04.2022 | Climate Solutions

Cool Update

Packaged Optyma™ Condensing Unit FH → FH² Compressor Change

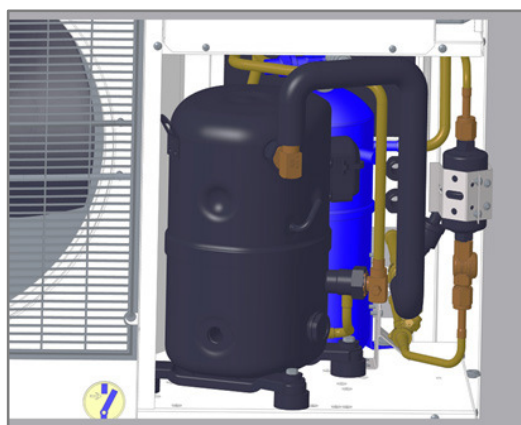
Changed technical features, tubing, and wiring of the condensing unit:

- Better cooling capacity +12 %
- Better COP +1 %
- Similar noise level
- Changed internal wiring diagram due to internal compressor capacitor change

Optyma Plus new lay out

Slim Pack new lay out
